ENGINEERING BULLETIN

Ref Document No.	EB15008	Issue No.	1
Subject	Water Pump Idler Pulley Improvement		
Release Date	19 th September 2015

Applicability – All in service COALTRAM® models – CT08, CT10, CT10LP, CT13

Figure 1: Original idler pulley

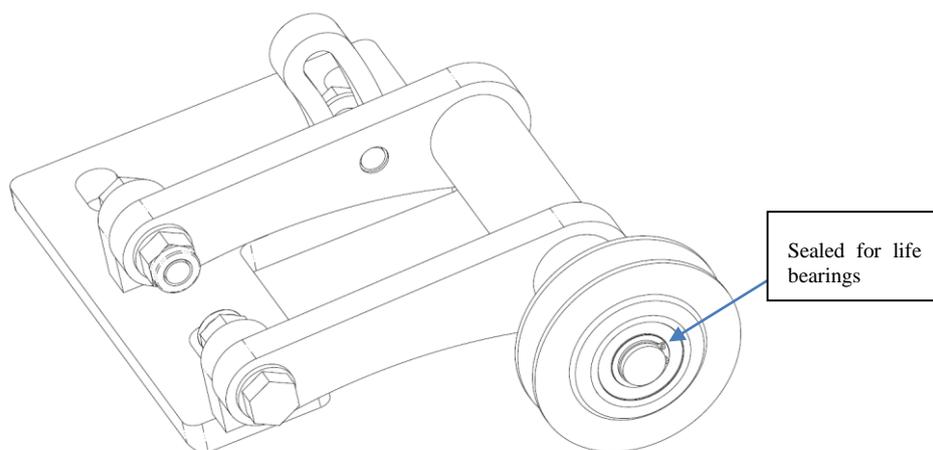
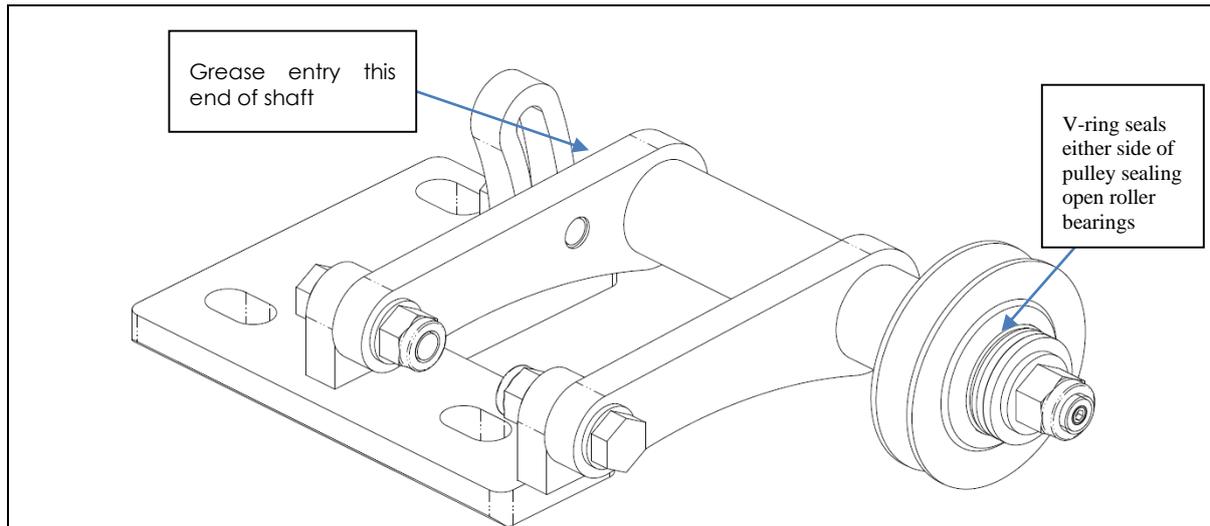
PPK has designed and trialled a new water pump tensioner pulley that uses bearings that have the ability to be greased. The new design replaces the sealed for life bearings with open bearings, includes grease porting in the supporting shaft and utilises v-ring seals to contain the grease and allow purging of old grease. The new design adds an extra grease point to the existing manifold mounted to the radiator cowl on the drivers side.

The old and new design are shown below:

1. PPK recommends installing the new water pump idler pulley for improved reliability and extended bearing life.
2. If the new idler pulley is installed remove the bearing change from the 500 hour service. Replace bearings (2 off - part number 5520009829) at the 1,000 hour service.
3. The retrofit components are currently available as a kit part number 5520009773. Contact your PPK service centre for organising installation or parts.
